REFERRAL REPORT

Report Date: September 2, 2025
Contact: Dr. Susanne Rühle
Contact No.: 604-326-4844
RTS No.: 18140
VanRIMS No.: 08-2000-20
Meeting Date: September 16, 2025

SUBJECT: CD-1 Rezoning: 11-15 East 4th Avenue

Level 6 Floor Plan (Original Submission)

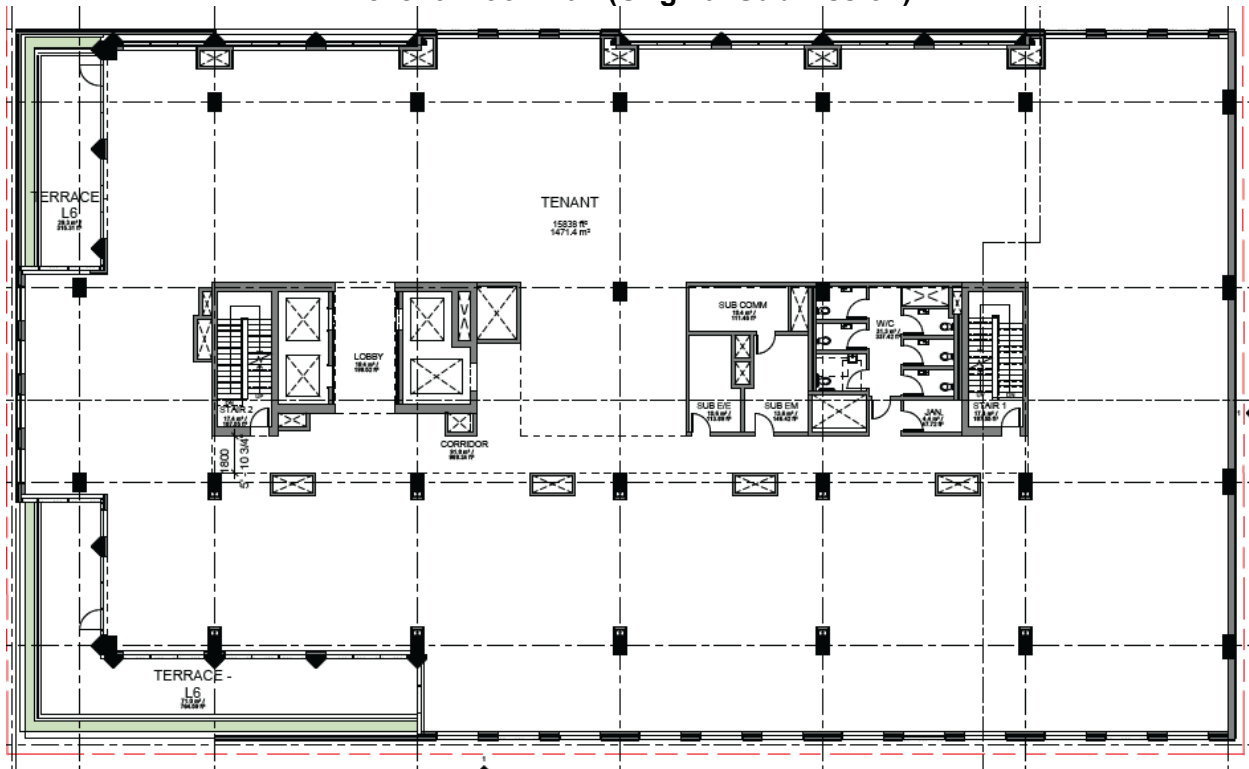
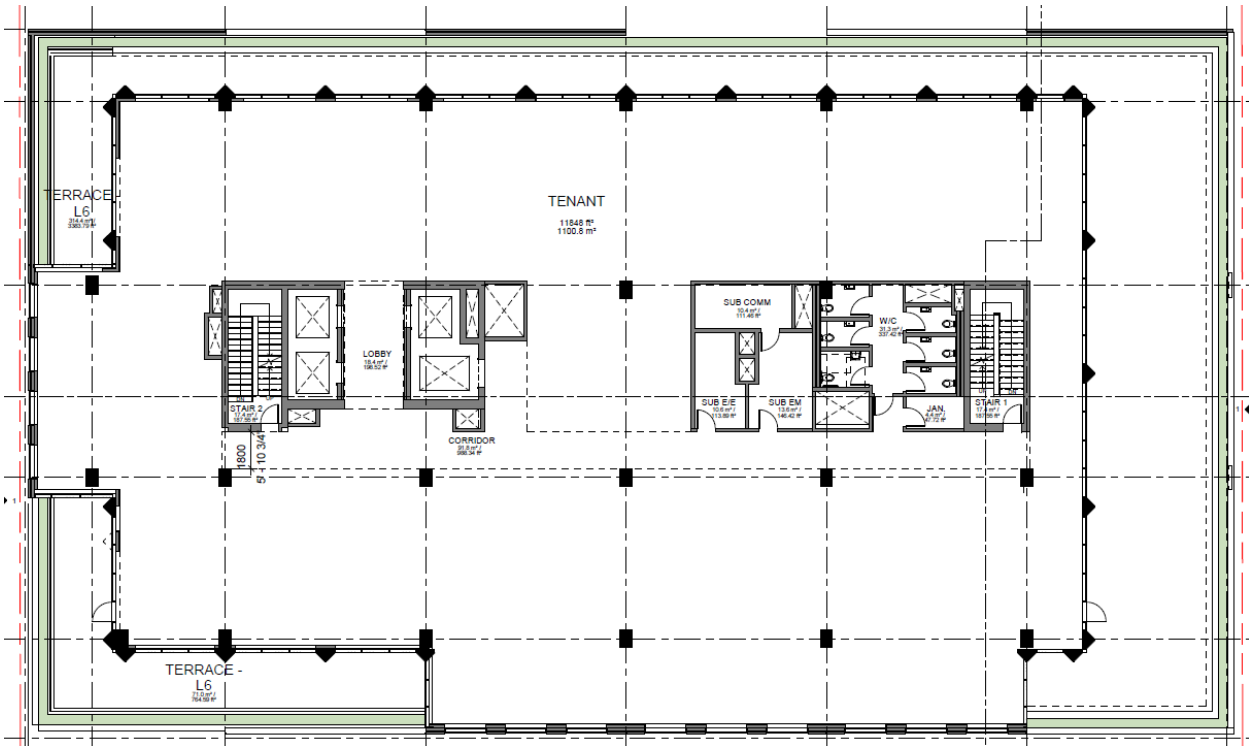
Tower Separation – The Plan anticipates a tower setback of no less than 7.6 m (25 ft.) starting above three storeys and at a height of 18.3 m (60 ft.). This is to ensure that an overall tower separation of 15.2 m (50 ft.) is accommodated equitably between the proposed development and future neighbouring tower development sites. The project as originally proposed included no tower setback to the east property line and provided 4.9 m (16 ft.) tower setback to the centreline of the lane.

Private Amenity Space – The development offers on-site common outdoor amenities for the building occupants at Level 6 and 7. Staff have prepared conditions to further improve the private amenity space.

Staff have prepared conditions in Appendix B to provide the required tower setbacks along the east property line and the centreline of the lane above the fifth storey, beginning at Level 6. A relaxation to the tower setback requirements can be considered, as the applicant has demonstrated through test fit analysis that providing the required tower setbacks above the fifth storey allows the upper massing at the Ontario Street and East 4th Avenue intersection to step back (see revised drawings in Appendix E).

- 1.1 Design development to provide the minimum required tower setback of 7.6 m (25 ft.) at levels above 18.3 m (60 ft.) in height or above three storeys as follows:

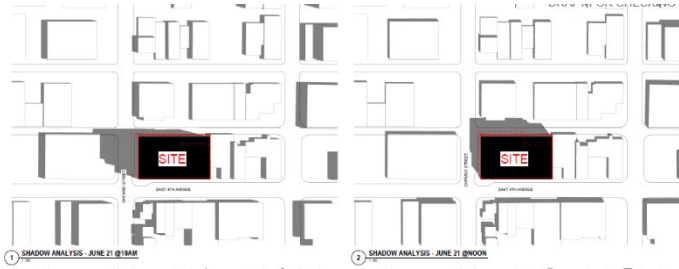
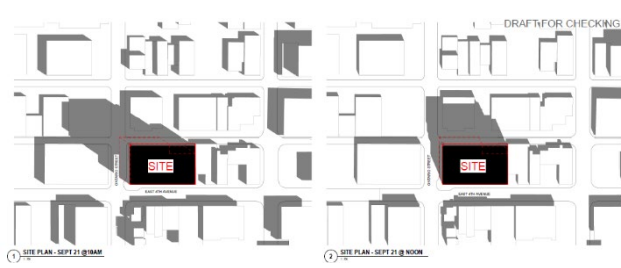
Form of Development – While the Plan anticipates a tower and three-storey podium typology, the application proposes an eight-storey tower with no podium (see Figures 2 and 3). As a result, the application does not comply with tower separation requirements as outlined in the Plan.

Figure 3: Proposal from Northwest perspective (Revised)
